# REGIONAL REVIEW NOTICE

ARC REVIEW CODE: R1611291

**Name of Proposal:** Saben Tatum Road (DRI #2646)

**SABEN “SF” TATUM ROAD DRI**  
**City of Palmetto**  
**Natural Resources Division Review Comments**

DRI PLAN

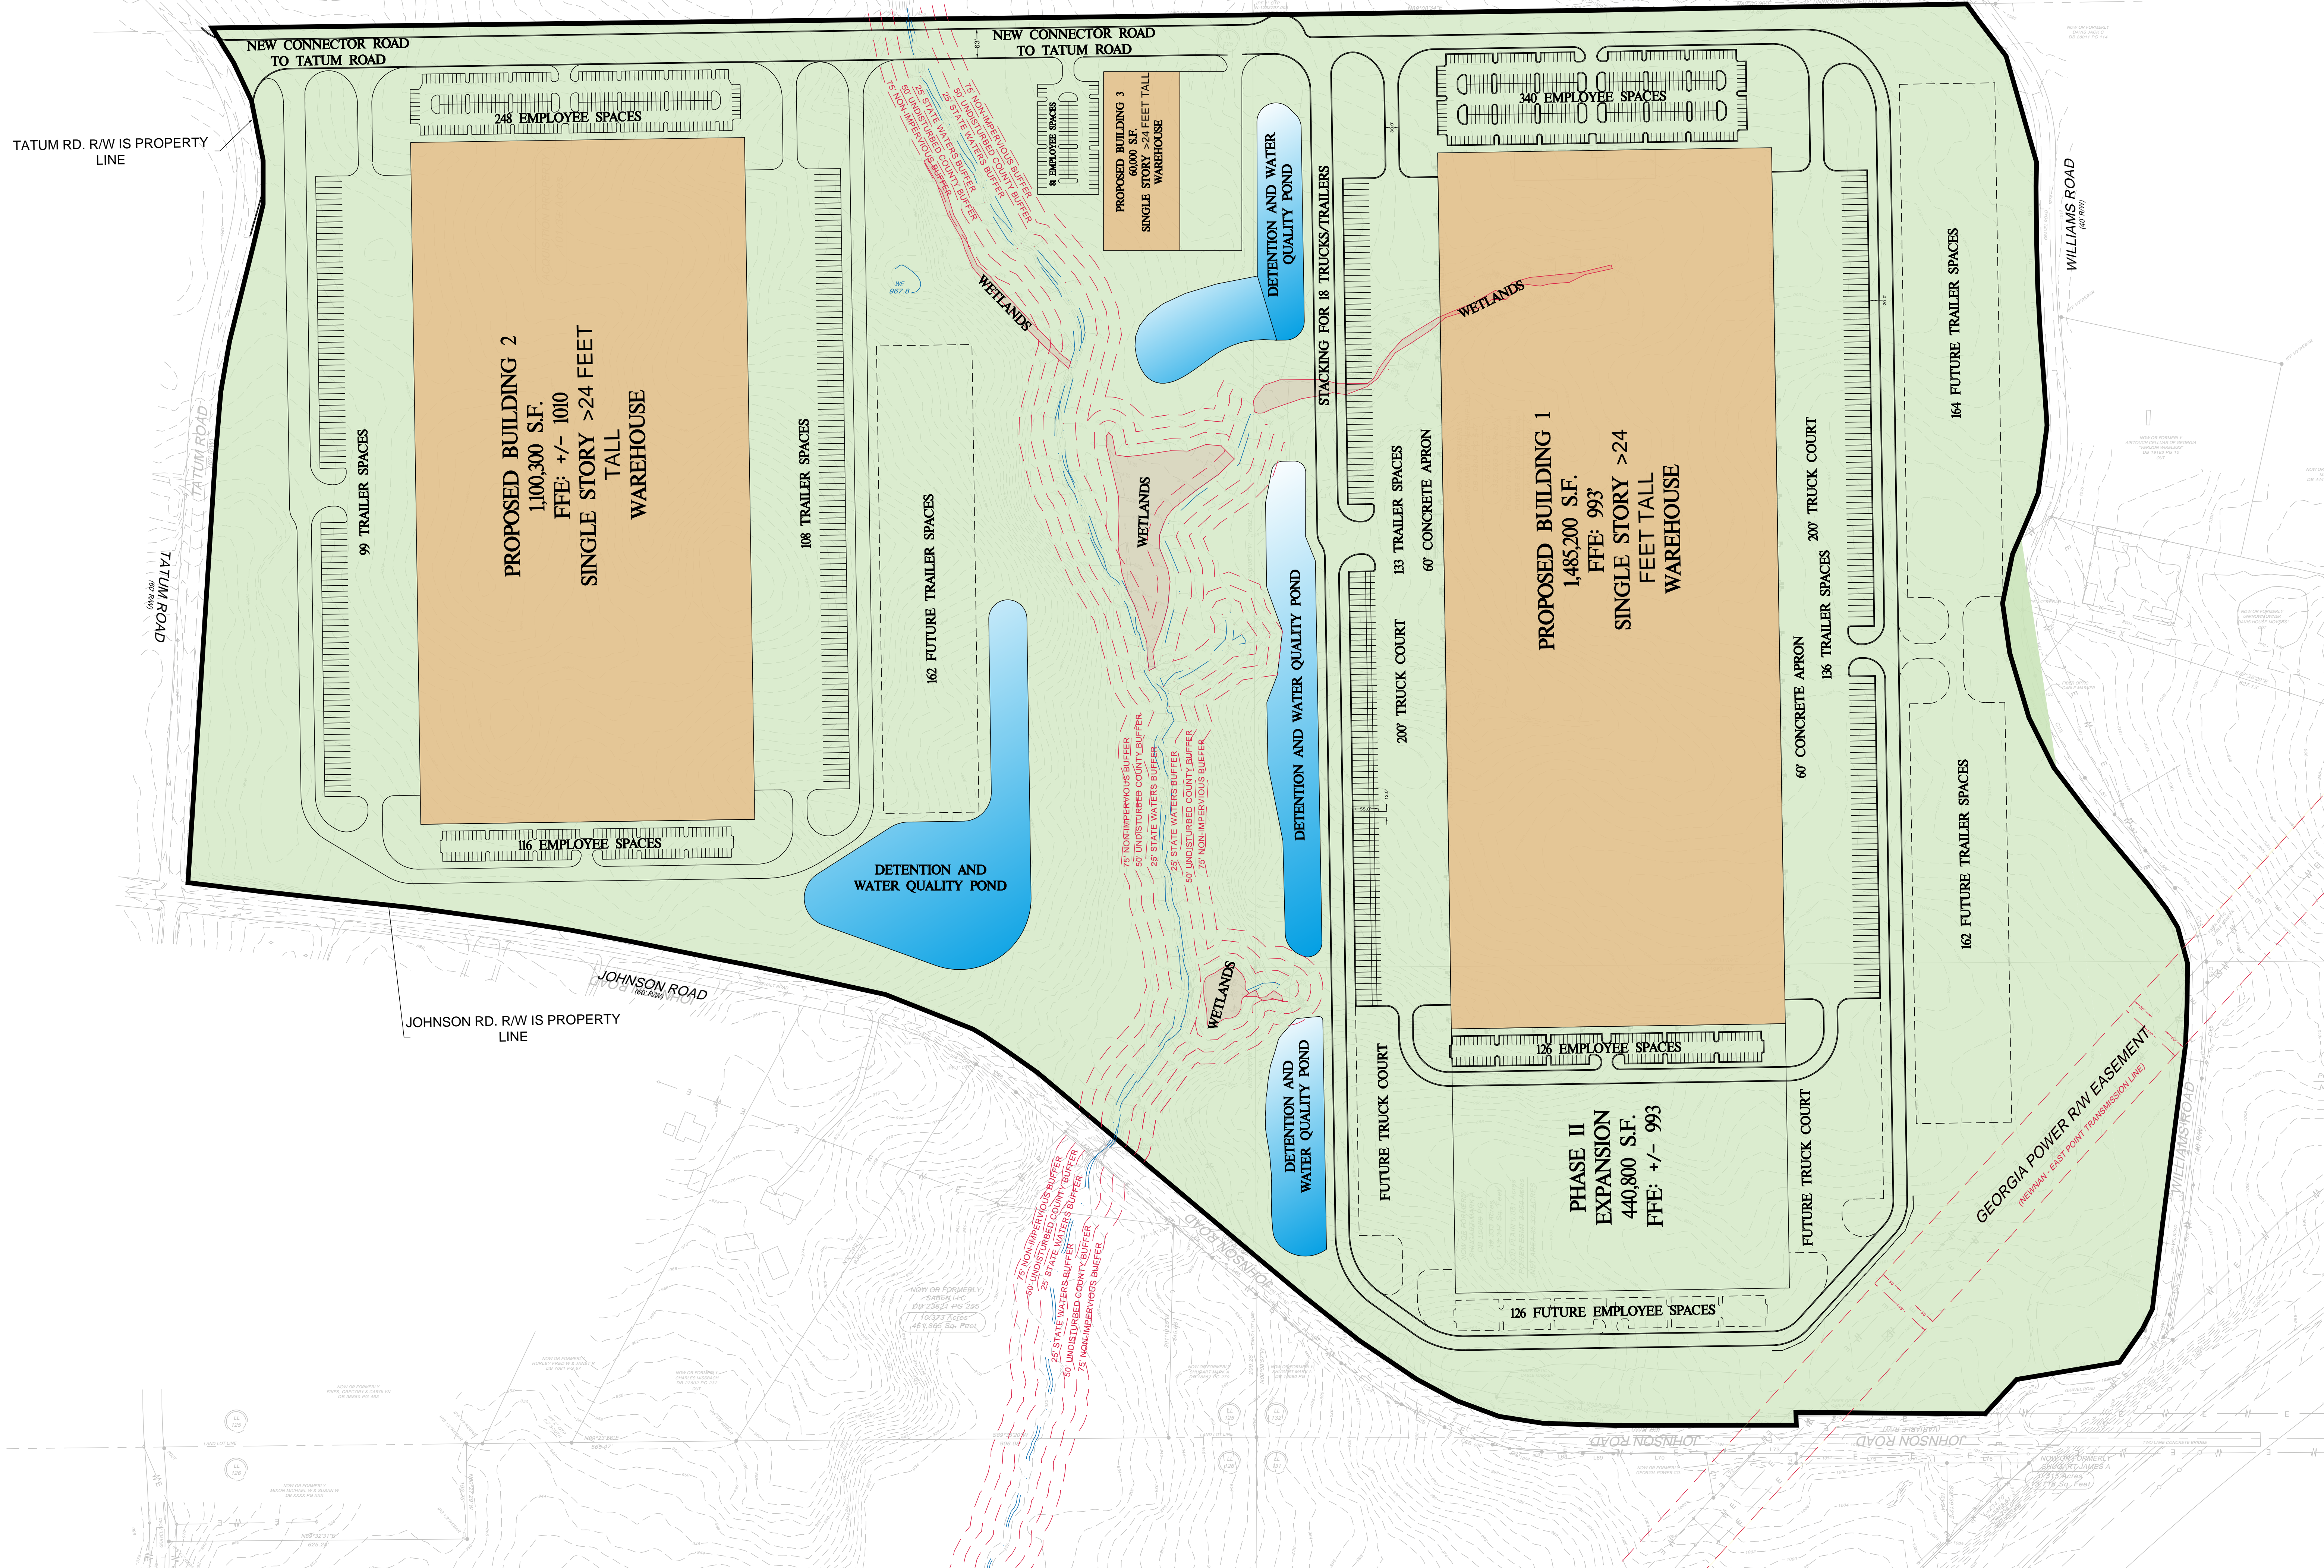
As stated above, the USGS coverage for the project area shows no blue line streams on or near the property. The submitted site plan shows a stream running north-south through the center of the property, with three short tributaries and wetland areas on the east side of the main stream. The 25-foot State Sediment and Erosion Control Buffer as well as a 50-foot undisturbed buffer and 75-foot impervious surface buffer are shown around all streams and wetland areas. The 50-foot and 75-foot buffers are consistent with both the Part 5 Water Supply Watershed Minimum Criteria and the City of Palmetto's stream buffer ordinance. Any other waters of the state that may be on the property will also be subject to the State Sediment and Erosion Control Buffer.

The site plan shows proposed detention and water quality ponds adjacent to the proposed developed areas of the property. The final design for stormwater controls on the property should adequately address the impacts of the proposed development on stormwater runoff and downstream water quality. Also, during construction, the project should conform to the relevant state and federal erosion and sedimentation control requirements. After construction, as with all development, water quality will be impacted due to polluted stormwater runoff. The amount of pollutants that will be produced after construction of the proposed development are dependent on the type and intensity of the use and the impervious coverage, which will affect the design of stormwater controls for the project.

The project site is adjacent to similar developed uses and or property currently designated for similar industrial uses. The site plan provided does not show provisions for future interconnectivity with adjacent parcels.

The site plan does not depict separate or designated facilities for safe travel via pedestrian and/or bicycle modes internal to the site. These modes may be used although limited to employees of the proposed use. One access to the site means the all modes will be share access and drive lanes.
